ENGINEERING MEMORANDUM

REPAIR SCHEME
DAMAGED NOSE SECTION

12833

DAMAGED NOSE SECTION

VIEW OF NOSE SECTION
LOOKING FORWARD

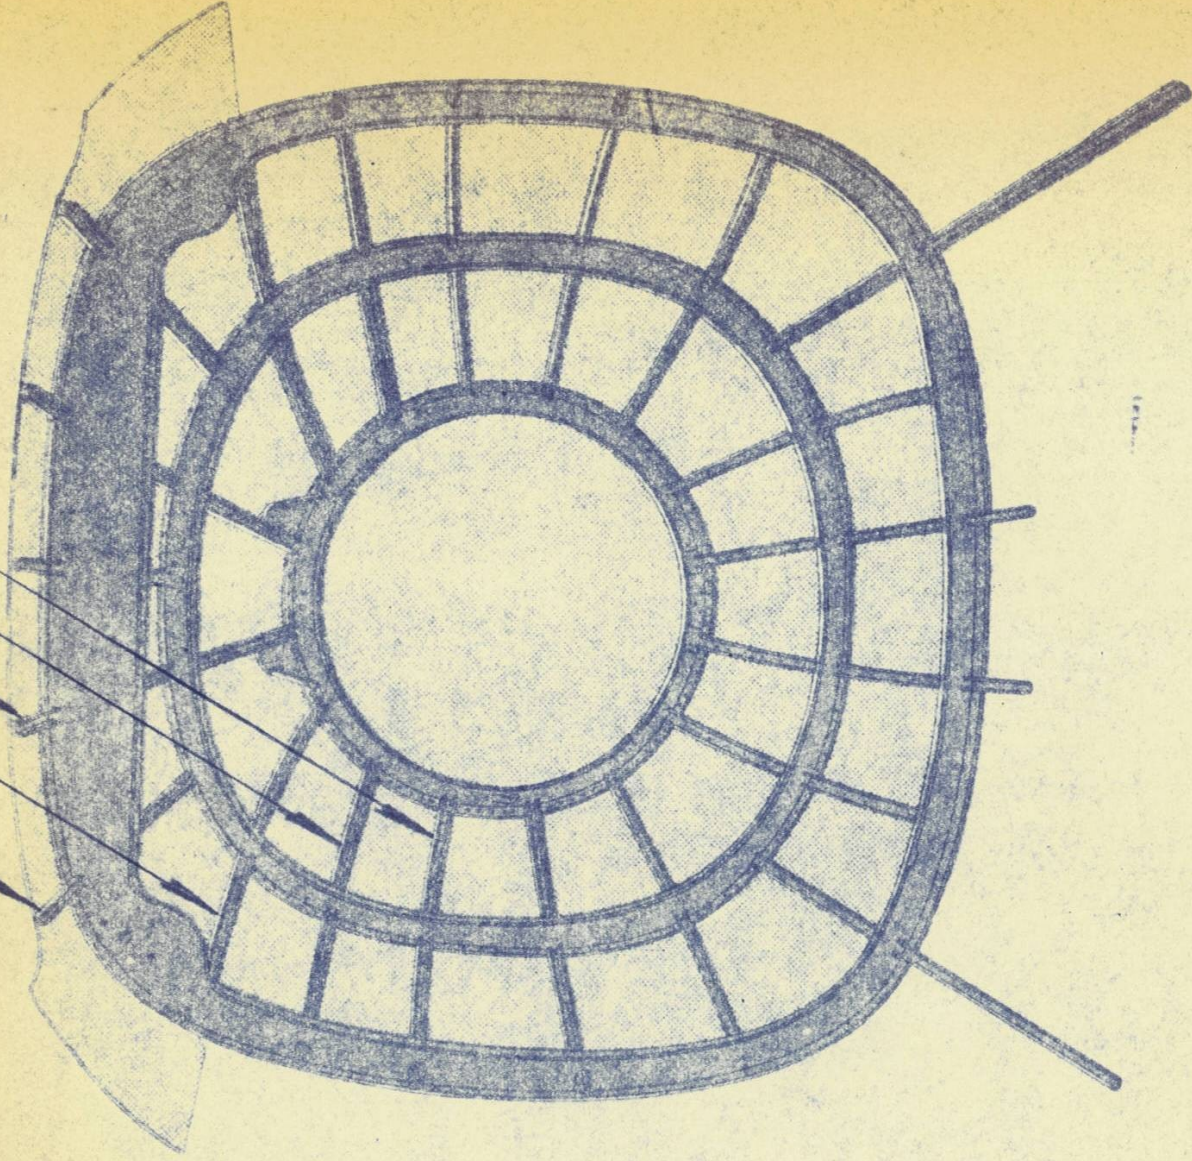
1. REMOVE EXISTING 404-184000-68 ICE PROTECTOR PLATE.
2. REMOVE EXISTING SKIN PATCH & DOUBLES.
3. REMOVE STRINGERS C184000-14, -18L, -19L, -20L & 404-184000-72 EXISTING AS INDICATED IN SKETCH ON PAGE 3.
4. PROPERLY SPLICE BULKHEAD 2 REPAIR SECTION TO 180417 CHANNEL ASS'Y AT TOP END & TO C184000-284 CHANNEL AT LEFT SIDE.
5. PROPERLY SPLICE C184000-284 CHANNEL AT REPAIR JUST AFT OF BULKHEAD 2.
6. MAKE & INSTALL NEW STRINGERS C184000-14, -18L, -19L, -20L & 404-184000-72.

- 404-184000-72
- C184000-18L
- C184000-14
- C184000-19L
- C184000-20L

7. INSTALL FLUSH TYPE SKIN PATCH ON INNER SKIN.
8. INSTALL NEW 404-184000-68 ICE PROTECTOR PLATE
